# Access Compliance Report

## Public Rights-of-Way

### (Curb Ramps)

Intersection ID: 5462	Main Street: CARVER_BV	Cross Street: CARVER_PL	Location: W
ADA ID: A0193C26C95E	Ramp Type: Para	Initial Pass/Fail: Fail	Overall Compliance: No
			Severity Score: 30

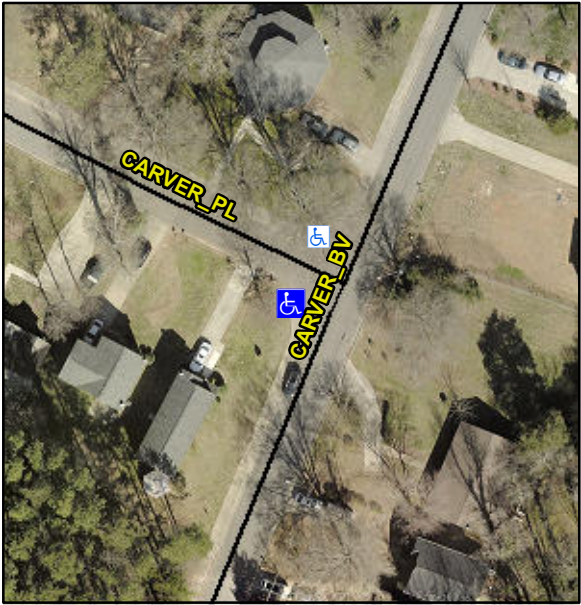
Codes/Mitigation Info/Possible Solution			Field Measurements/Component Compliance		
	Possible Solutions:		<b>Compliance</b>	<b>Description</b>	<b>Data</b>
	<b>Remove &amp; Replace Entire Ramp.</b>		<b>N/A</b>	Ramp Length LT (in)	<b>66.0</b>
			<b>No</b>	Ramp Width LT (in)	<b>35.0</b>
			<b>Yes</b>	Ramp Slope LT (%)	<b>6.0</b>
			<b>Yes</b>	Ramp XSlope LT (%)	<b>1.1</b>
			<b>N/A</b>	Landing Length (in)	<b>N/A</b>
			<b>N/A</b>	Landing Width (in)	<b>N/A</b>
			<b>N/A</b>	Landing Slope (%)	<b>N/A</b>
			<b>N/A</b>	Landing X Slope (%)	<b>N/A</b>
			<b>N/A</b>	Landing Curb? (Y/N)	<b>N/A</b>
<p>Surveyor Notes:</p> <p><b>N/A</b></p> <p>PROW/ADA:</p> <p><b>R304.5.1, R304.3.2</b></p>			<b>N/A</b>	Ramp XSlope RT (%)	<b>1.2</b>
			<b>N/A</b>	DWS Provided?	<b>N/A</b>
			<b>N/A</b>	DWS Contrast?	<b>N/A</b>
			<b>N/A</b>	DWS Length (in)	<b>N/A</b>
			<b>N/A</b>	DWS Full Width?	<b>N/A</b>
			<b>N/A</b>	DWS Offset (in)	<b>N/A</b>

<b>N/A</b>	Gutter Slope (%)	<b>N/A</b>
			<b>N/A</b>	Gutter X Slope (%)	<b>N/A</b>
			<b>N/A</b>	Painted X Walk1?	<b>No</b>
			<b>N/A</b>	X Walk 1 Direction	<b>To NE</b>
			<b>N/A</b>	X Walk 1 Width (in)	<b>N/A</b>
				X Walk 1 Slope (%)	<b>4.6</b>
				X Walk 1 X Slope (%)	<b>1.9</b>
			<b>N/A</b>	Ramp inside XWalk1?	<b>N/A</b>
				Road Slope (%)	<b>N/A</b>
				Road X Slope (%)	<b>N/A</b>
			<b>N/A</b>	Any Obstructions?	<b>N/A</b>
				Obstruction Type	
			<b>N/A</b>	Storm Grate/Utility Hazard?	<b>N/A</b>
				Storm Grate/Utility Type	
Total Cost:		<b>\$ 1600.00</b>	<b>N/A</b>		<b>N/A</b>
			<b>Yes</b>	Surface Condition? (G/P)	<b>Good</b>
			<b>N/A</b>	Curb Slope (%)	<b>19.3</b>
